A Repair

SEWAGE DISPOSAL SYSTEM

MARYLAND STATE DEPARTMENT OF HEALTH*

SUBDIVISION ROAD 6547 Cedar Lane

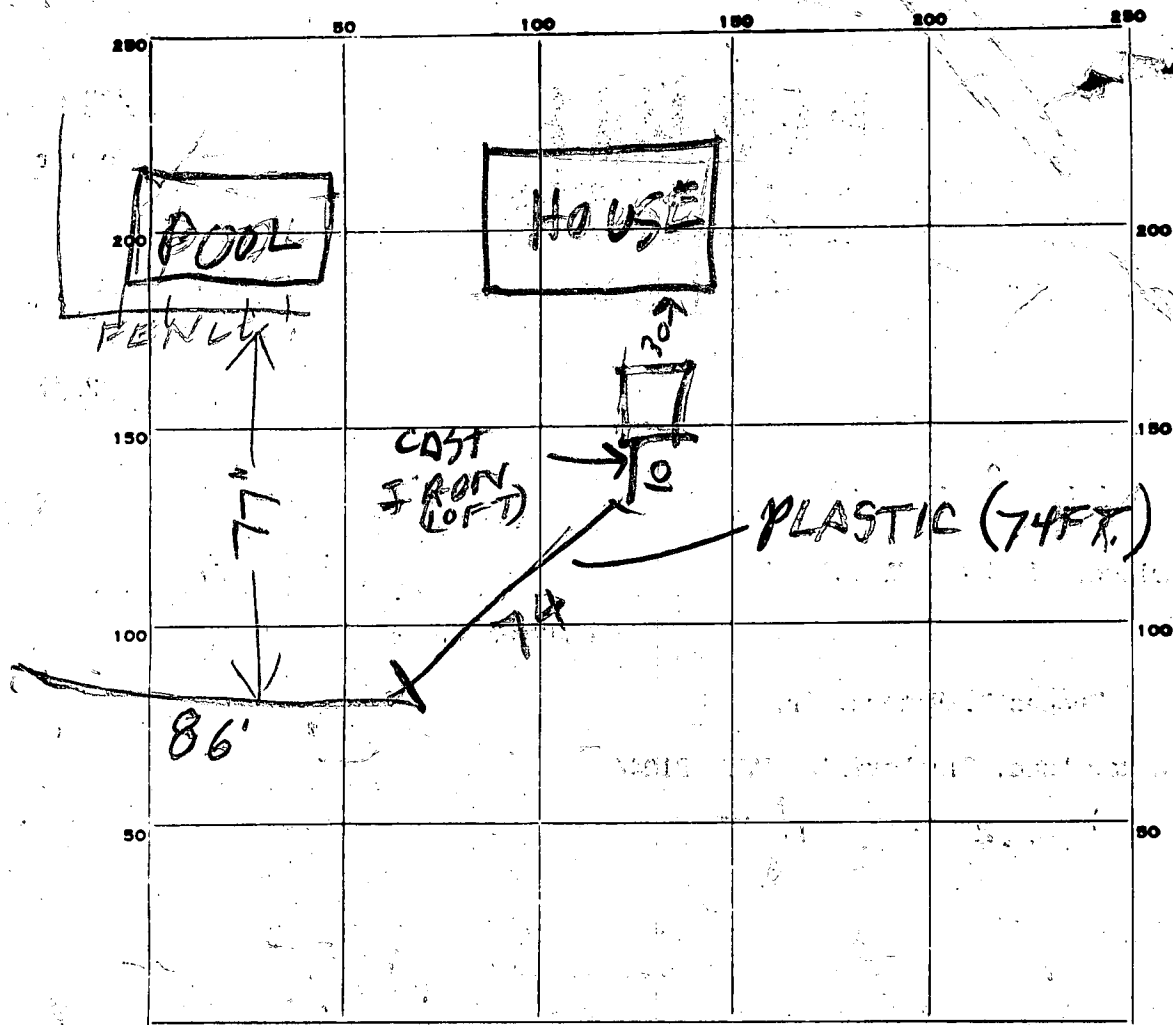
REPAIR - Call for an appointment when ground is opened up and Sanitarian will

recommend repair system.

OK TO USE PLASTIC

PIPE TANK TO TRENCH PER D.M.

OK for metal tank

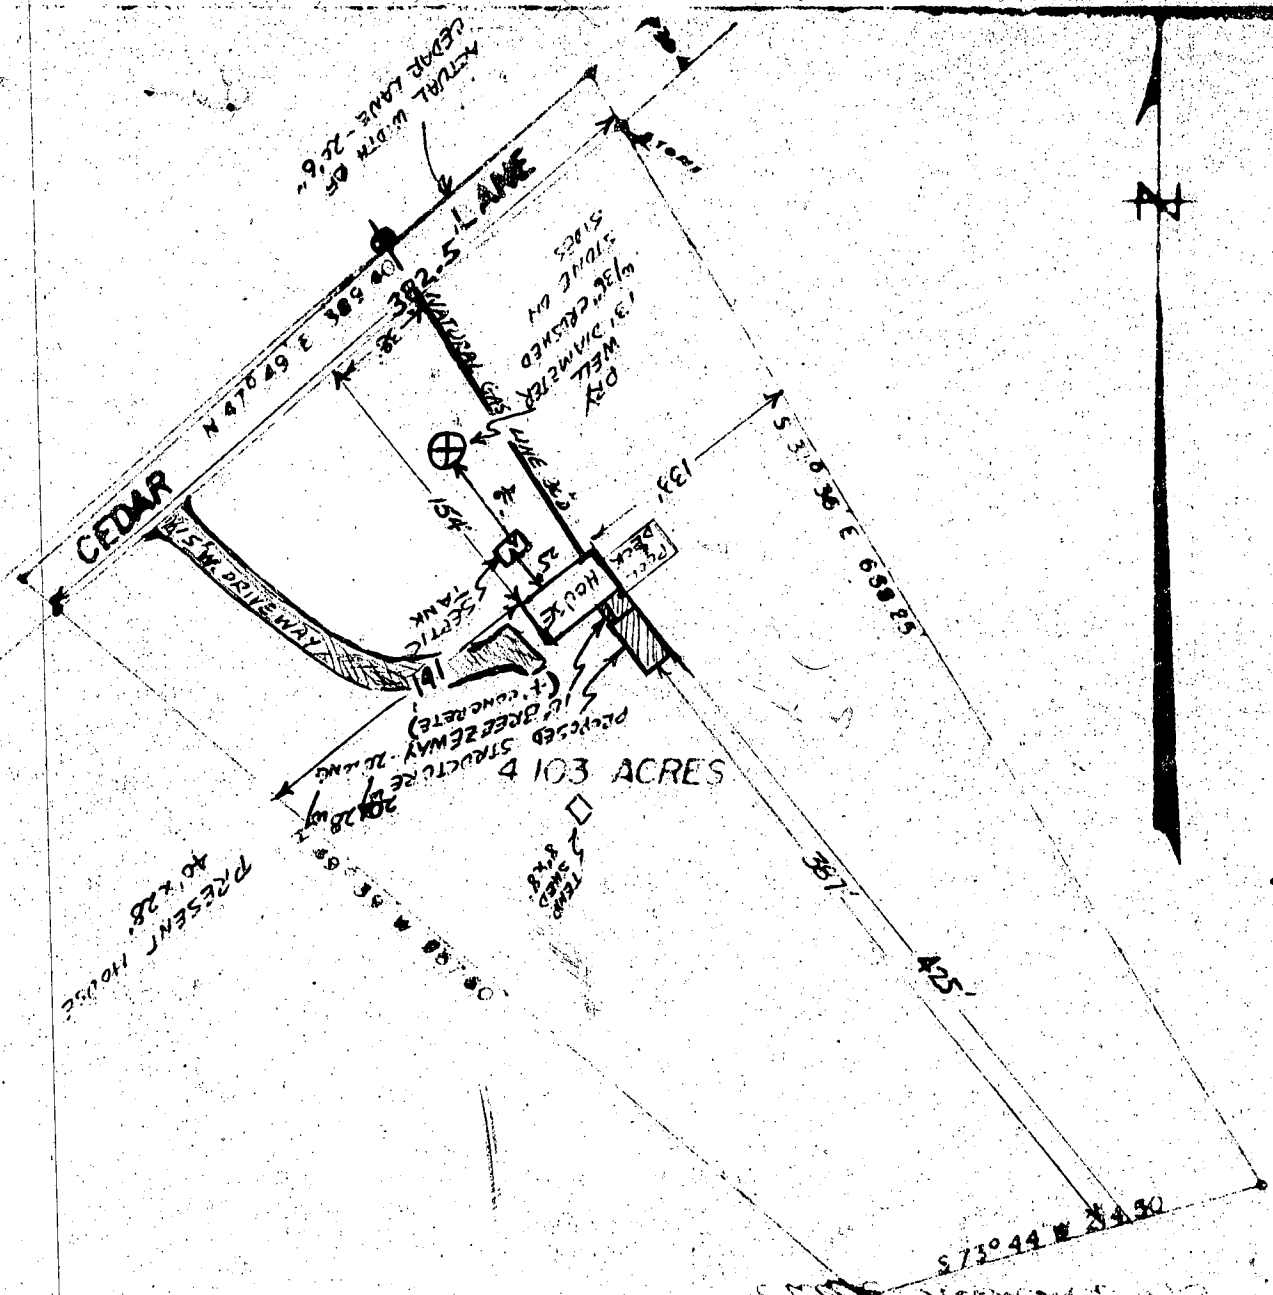
REMARKS 6/6/79 AM DITCH DUG 80 FT LONG WITH AV DEPTH OF 6 FT & 20 FT LONG WITH AV DEPTH OF 3 FT SOIL SANDY BUT VNEVEN ROCK BOTTOM BY 6/6/79 PM STONE ADDED TO DITCH OK TO COVER DITCH.

BUT NEW TANK NEEDED. CALL FOR INSPECTION OF TANK & SEWER WORK

DATE SYSTEM APPROVED 6/7/79 INSPECTOR Raymond Hodges
